Sydney Metro - Western Sydney Airport (SSI-10051)
Submission on the Environmental Impact Statement dated October 2020

This letter has been prepared by Celestino Developments SSP Pty Limited (**Celestino**), the developer of Sydney Science Park (**SSP**), to provide feedback on the Sydney Metro – Western Sydney Airport Environmental Impact Statement (**EIS**).

Figure 3

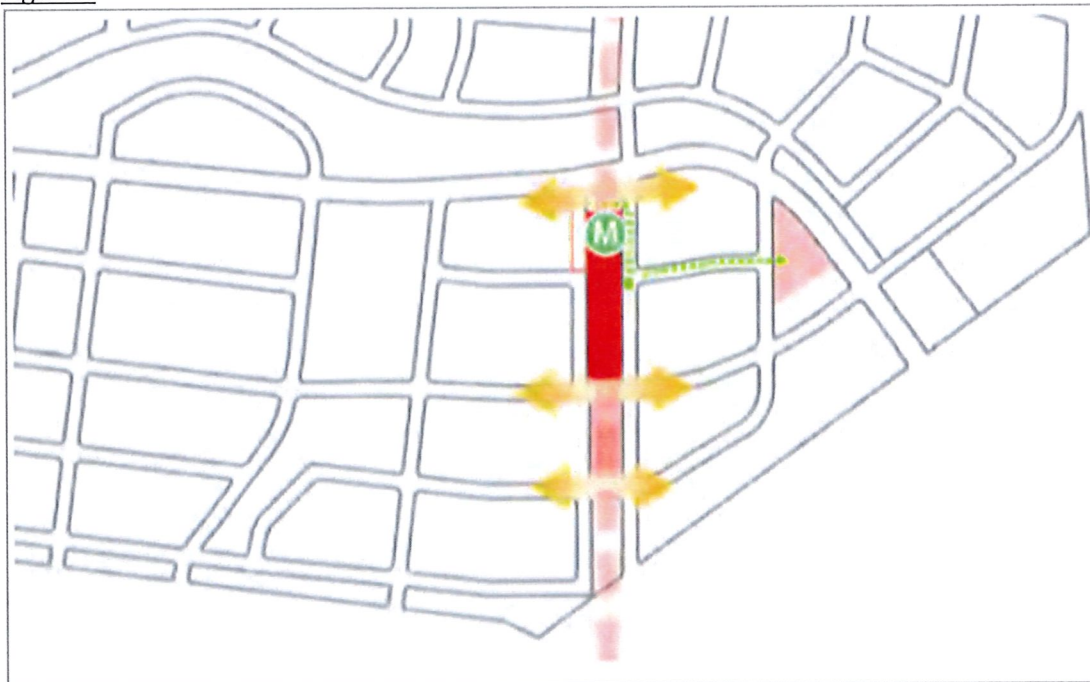
The current zoning of SSP, the maps contained in the proposed Northern Gateway Precinct Plan and the maps contained in the EIS (refer Figures, 1, 3 and 4 respectively) all show different orientation and layouts of roads and intersections with Luddenham Road. Celestino would like to discuss the proposed road layouts (structure) and intersections connecting to Luddenham Road with Sydney Metro and Western Sydney Planning Partnership.

Action No 1 - Sydney Metro to work with Celestino & WSPP to resolve the urban design and road network, including intersections with Luddenham Road.

Figure 5

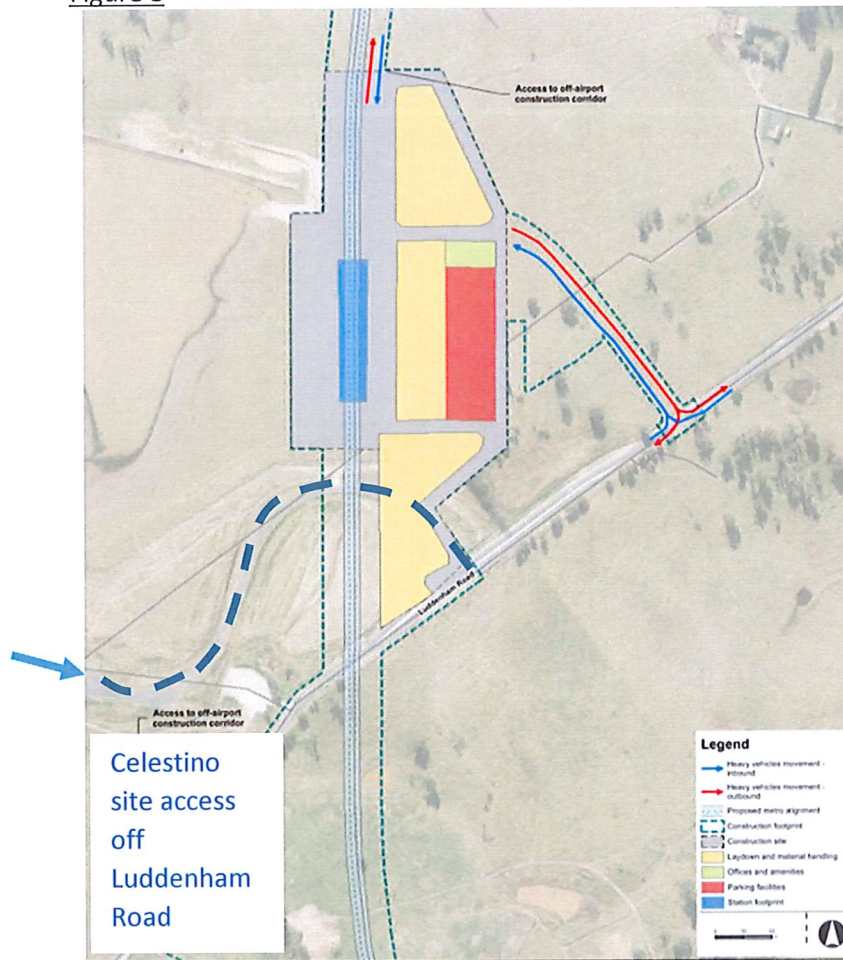
- a. Celestino is planning to start construction at Sydney Science Park in 2021. Figure 5 (Figure 8-22 provided in Chapter 8 – Project Description – Construction of the EIS) outlines Sydney Metro's intended use of the site during construction. The image also shows Celestino's current access (dotted line) to the project from Luddenham Road. Celestino needs to be assured that its current access from Luddenham Road will be maintained throughout Sydney Metro's construction and operation.

- d. The proposed rail alignment and bus layover location (Figure 5-7 in Technical Paper 1) impacts the existing SSP road access. This access will be utilised for both construction and operational access.

Action No 4 - Sydney Metro to undertake further consultation to confirm staging to ensure SSP access is not restricted for either construction or operation from the Celestino site access off Luddenham as delineated in the figure below.

Action No 6 - Sydney Metro to undertake further consultation to confirm staging to ensure SSP access is not restricted for either construction or operation from the Celestino site access off Luddenham Road as delineated in Figure 5.

Figure 6

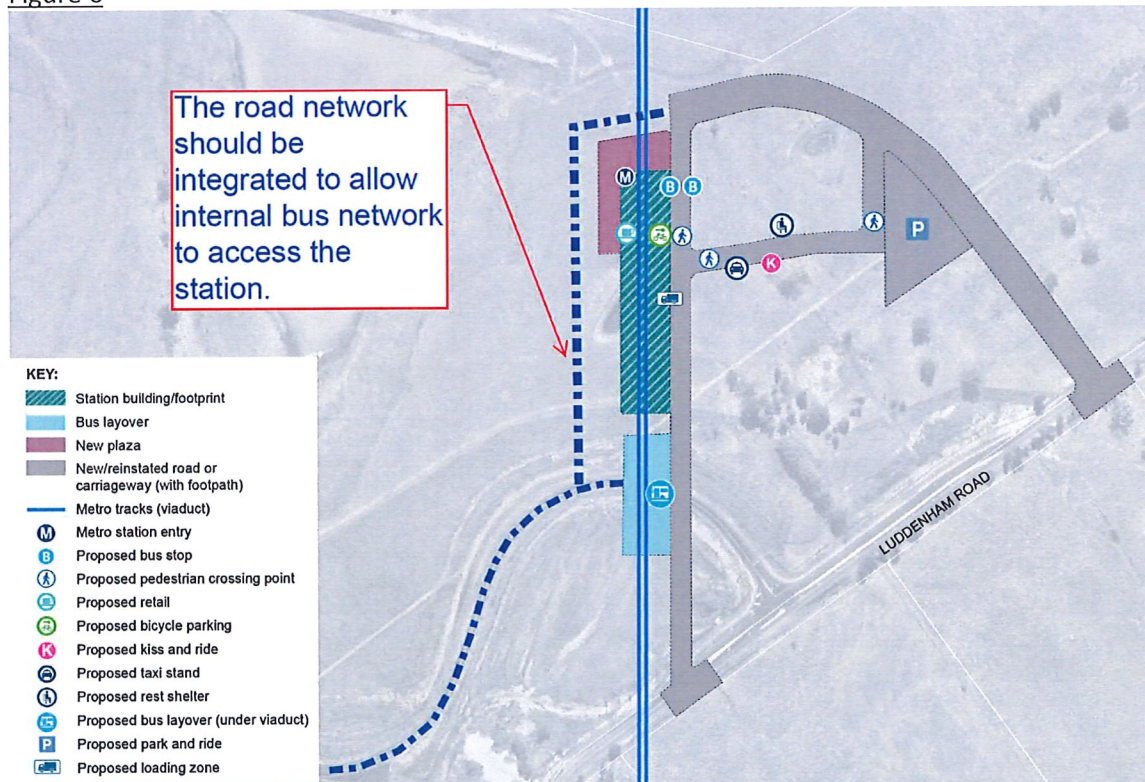
- a. Celestino is supportive of potential additional regional bus services that may be provided by TfNSW within the study area to enable connectivity between surrounding local and regional centres (section 5.1.2). Opportunities should be explored to connect the internal interchange road to the north of the station (refer Figure 6 for further context). This could allow internal bus access from the interchange into SSP without the need to travel back via Luddenham Road.

- b. The interchange layout plan identifies a location of a bus layover area to the south of the North Luddenham Station. Celestino would like to understand the following in relation to the proposed bus layover:
 - i. The spatial dimensions and any requirements for bus driver facilities
 - ii. The type and function of the layover (e.g. recovery, positioning, driver breaks etc)
 - iii. The overall capacity requirements of the bus layover
 - iv. The number of bus movements and circulating patterns within the interchange (and whether these have been included in the operational traffic analysis of key intersections along Luddenham Road).

Figure 7-23 in Chapter 7 of the EIS (“Luddenham Road Station – indicative layout and key design elements”) proposes a station entry and new plaza on the northern side of the above ground station platforms. The New Precinct Street (North) – which has a full movement intersection with Luddenham Road seems to be the main vehicular route in and out of the SSP. This would place the ‘pedestrian focused station entry and plaza’ immediately adjacent to the main vehicular route for the wider precinct.

Action No 8 - Celestino requests Sydney Metro clarify the bus routes internally through SSP to ensure appropriate bus capable street layouts can be provided and coordinated with Sydney Metro's and the Western Sydney Planning Partnership masterplan.

Action No 11 – High vehicle routes directly adjacent the station plaza/entry should be minimised. Metro should work with Celestino to ensure the plaza and entry is adequately located away from high rates of passing traffic and integrates with the wider masterplan for improved amenity and connectivity.
